604123-111717

ADDENDUM NO. 5

**Federal Aid Project Nos. CMQ-003S(390), STP-003S(390) & TAP-003S(390)
Roadway Reconstruction and Related Work along Route 126 (Pond Street)**

Transmitting revisions to the Contract Documents as follows:

STATE	FED. AID PROJ. NO.	SHEET NO.	TOTAL SHEETS
MA	CMQ/TAP/STP-003S(390)	201	331
PROJECT FILE NO.			604123

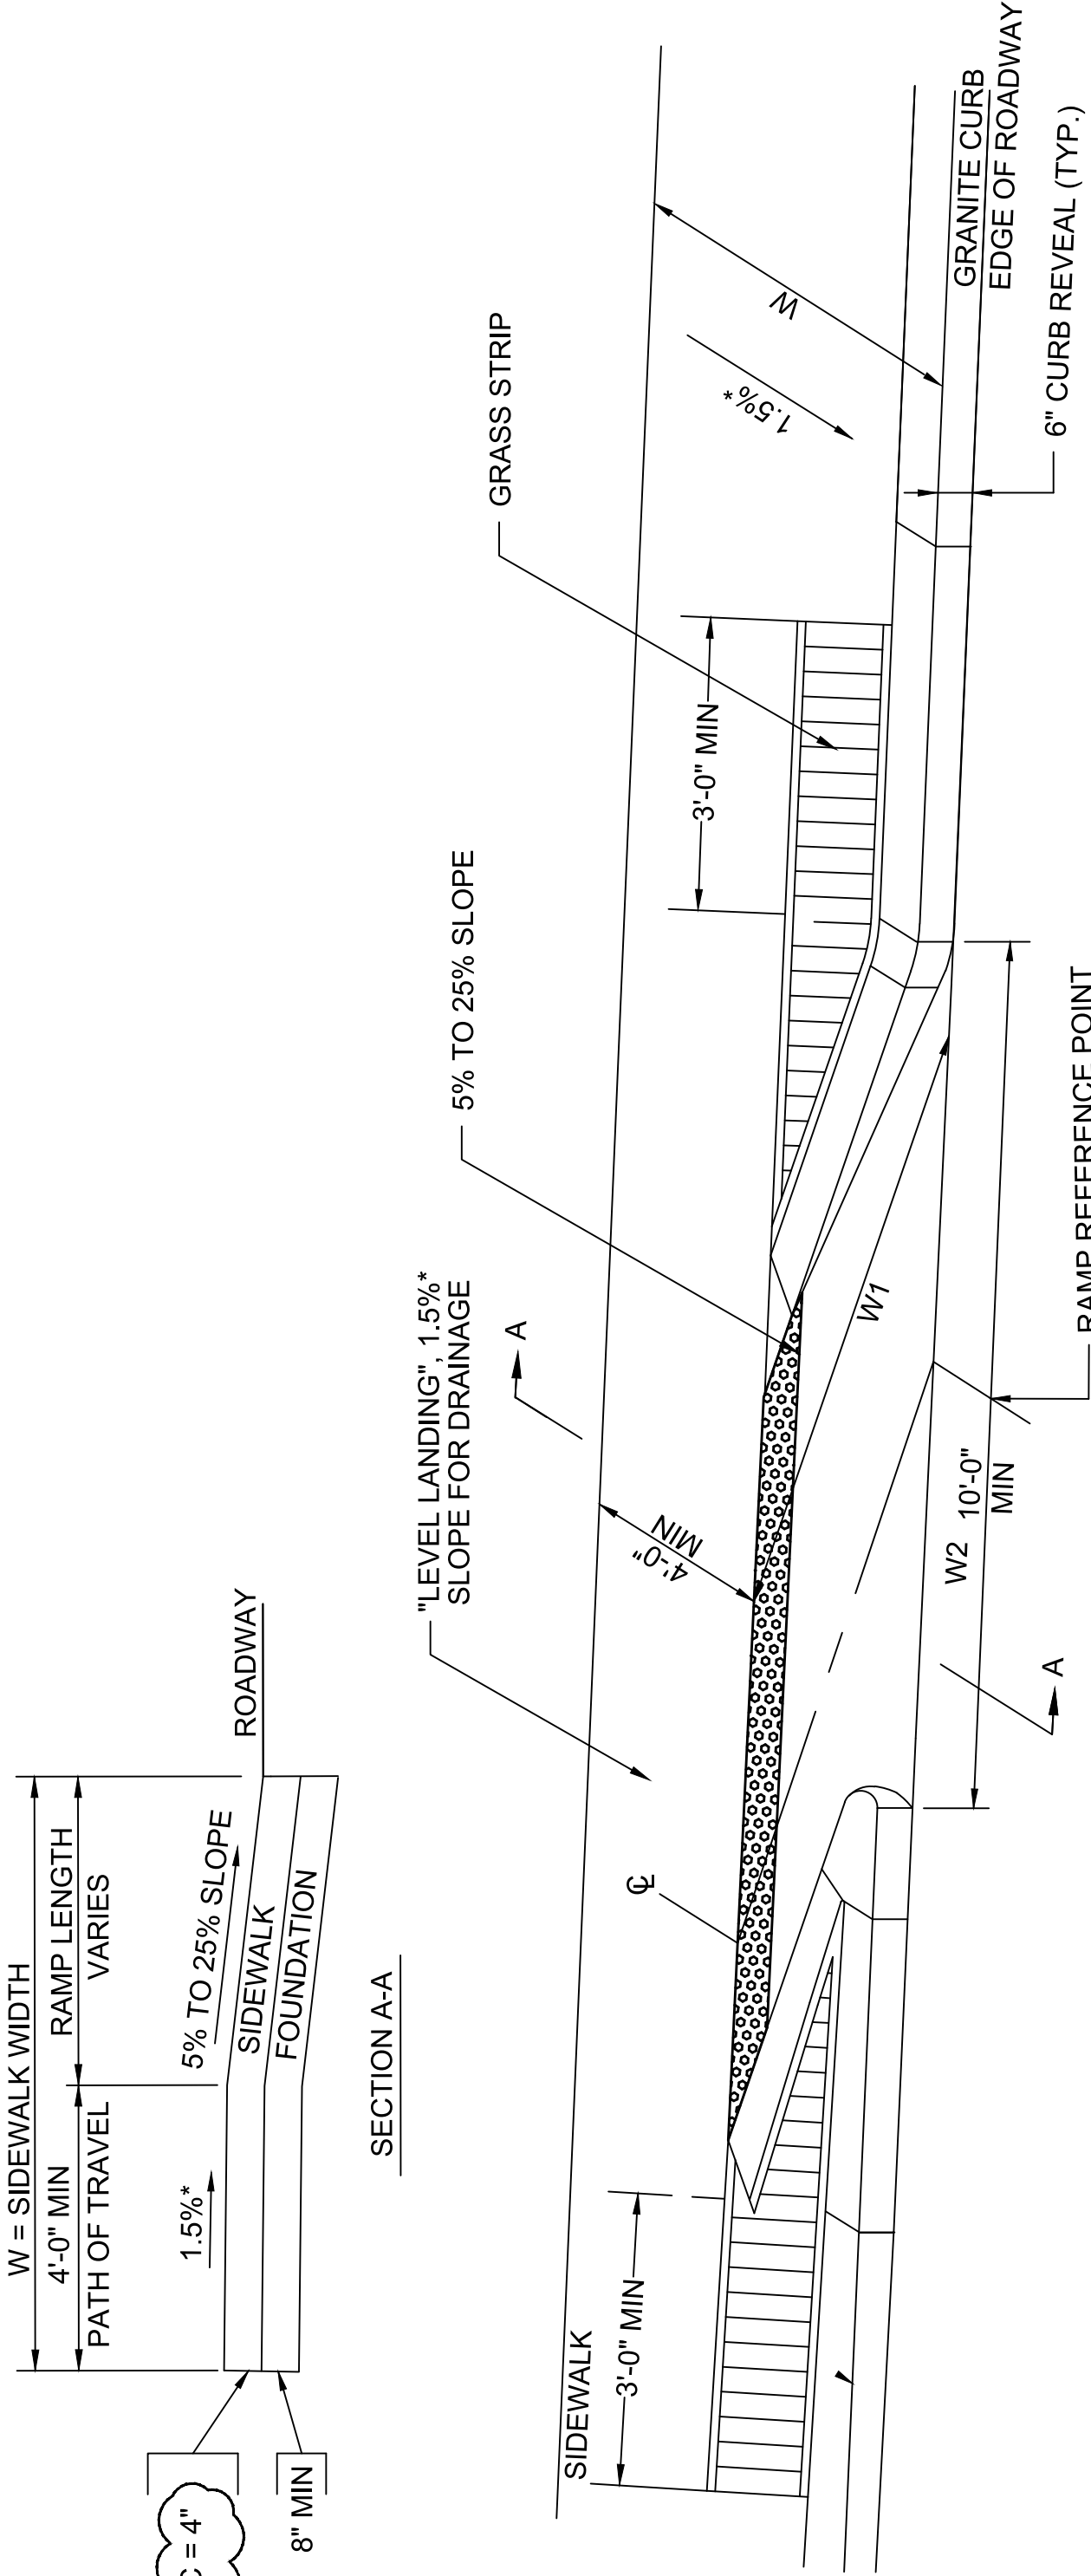
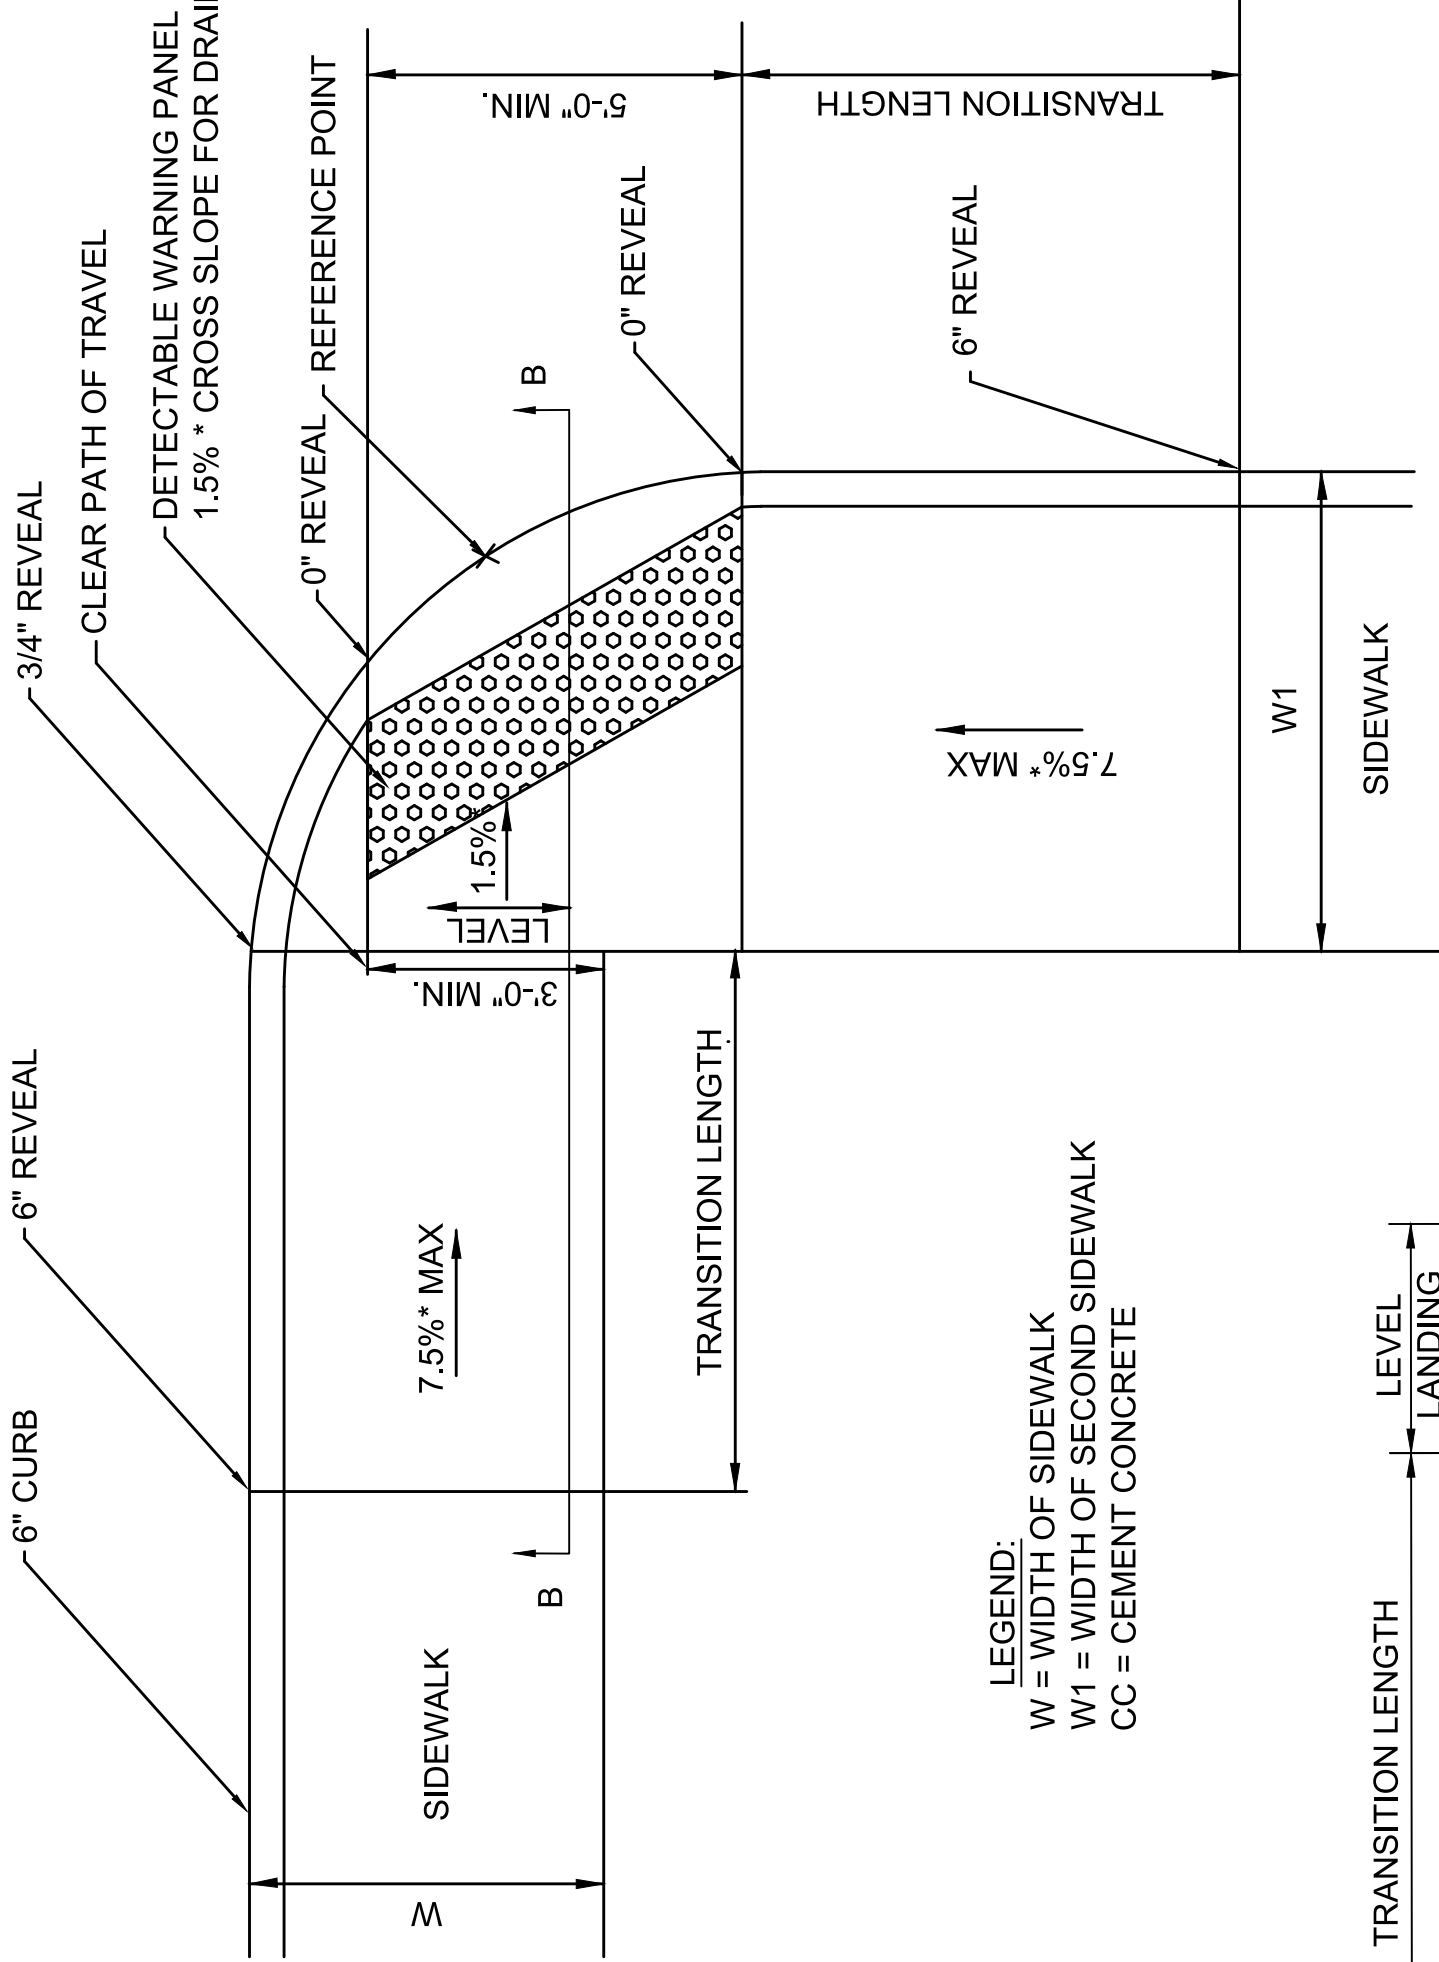
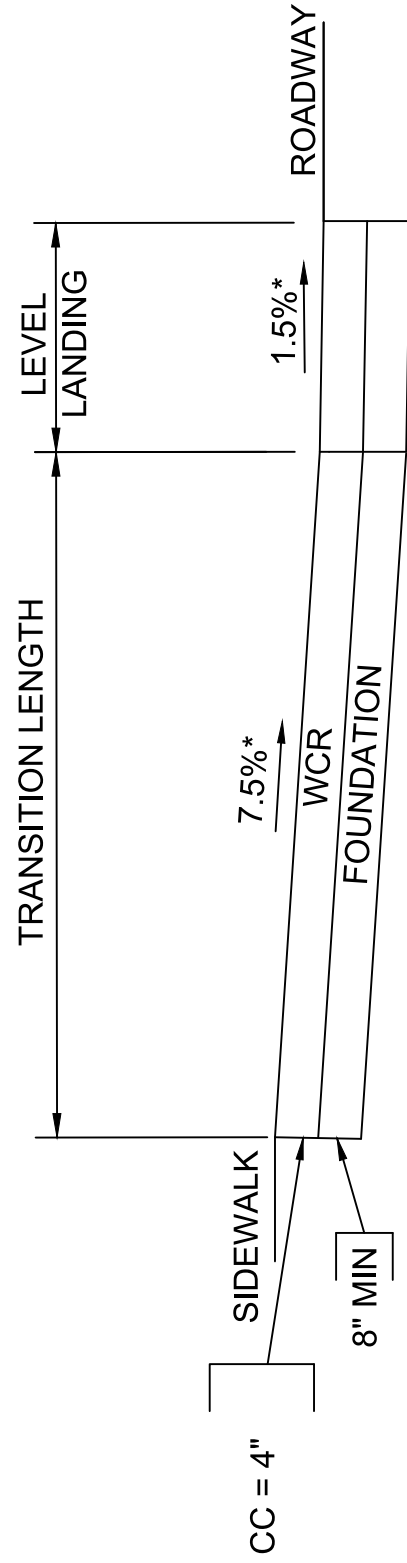
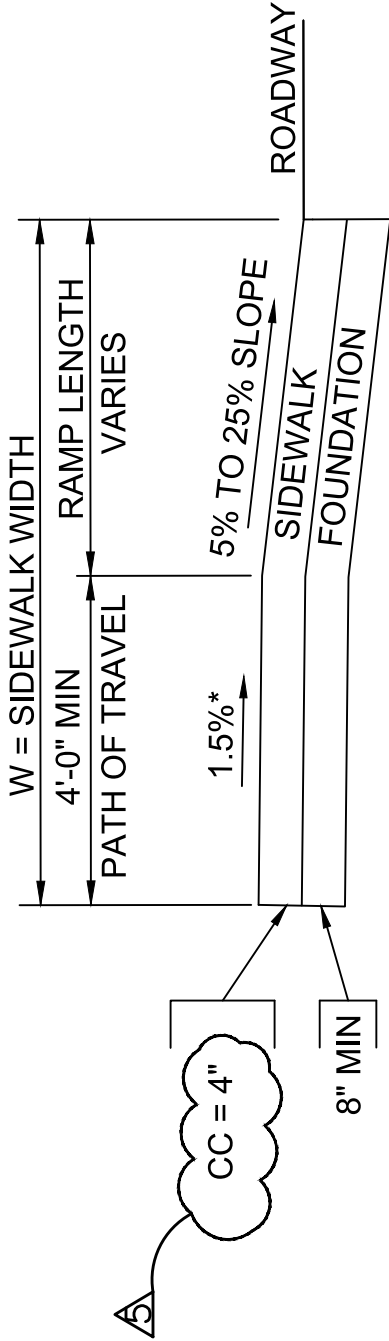
Question #51: Under what bid item shall the Proposed Cement Concrete Bike Ramps be paid under?

Response #51: The proposed cement concrete bike ramps are paid under Item 701.2. See revised Sheet 201 of 331.

**ELIOT STREET RETAINING
WALL PLAN AND ELEVATION
SHEET 1 OF 2**

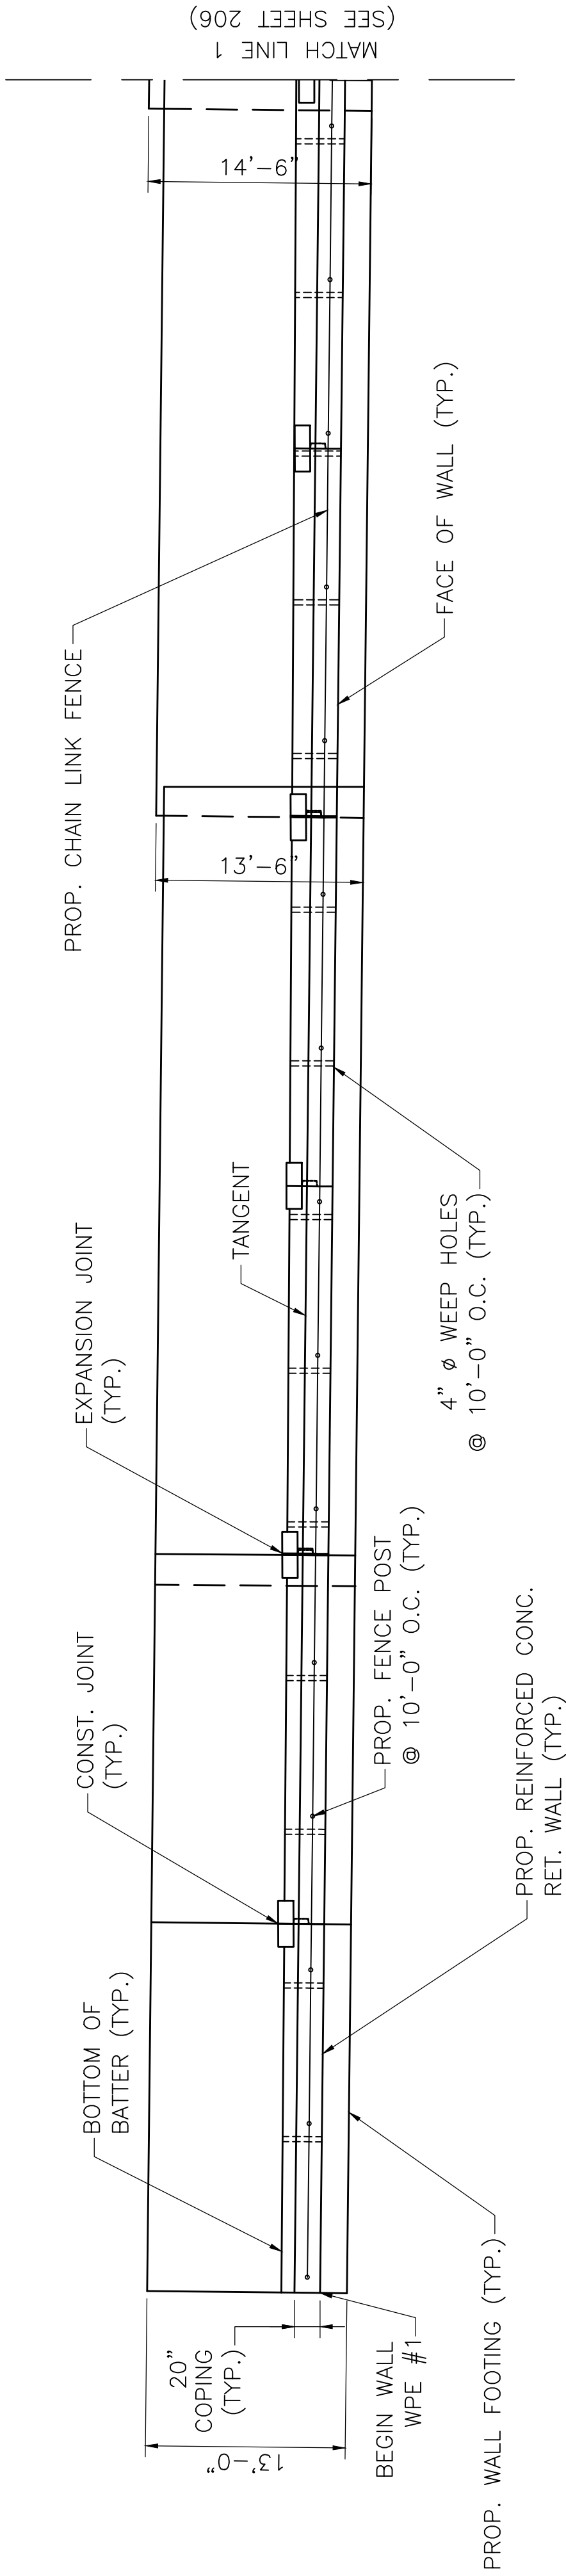
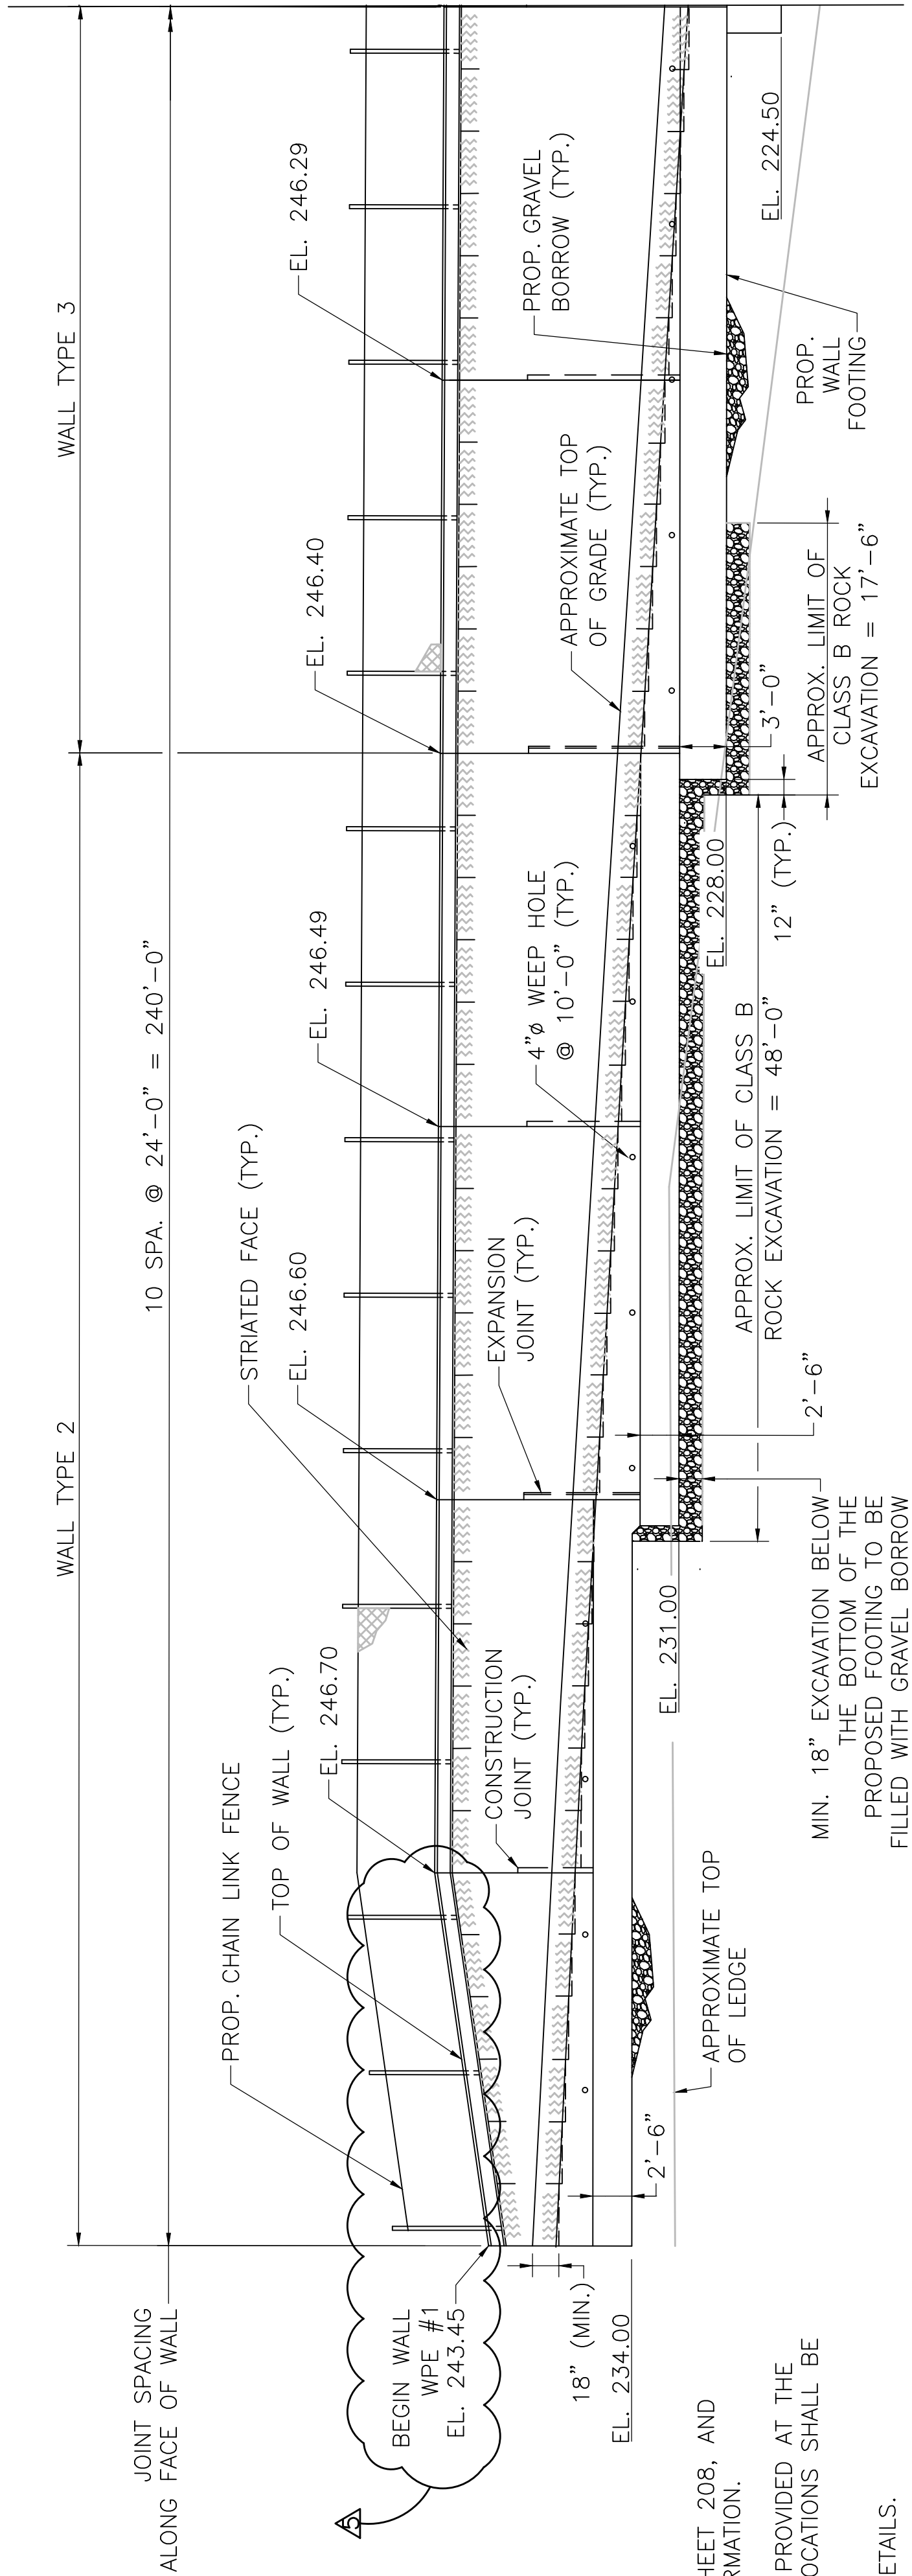
Question #28: At the start and end of Eliot St. retaining wall, the exposed heights are +/-7' +/-10' respectively. Can the wall ends be extended or grading plans be provided for the Eliot St. wall ends as this seems extremely high to have the retaining walls end at those heights.

Question #41: The plans for the Eliot Street retaining wall include footing elevations that differ from the elevations shown in the cross section. At station 32+50, the cross section shows the bottom of the footing for the wall slightly below 232'. The Plans show the footing to be placed at 234'. Please clarify which drawing will govern.

Response #28: See revised Sheets 205 and 206 of 331.

Response #41: The plans for the Eliot Street retaining wall will govern the bottom of footing elevation. See revised Sheets 205 and 206 of 331.
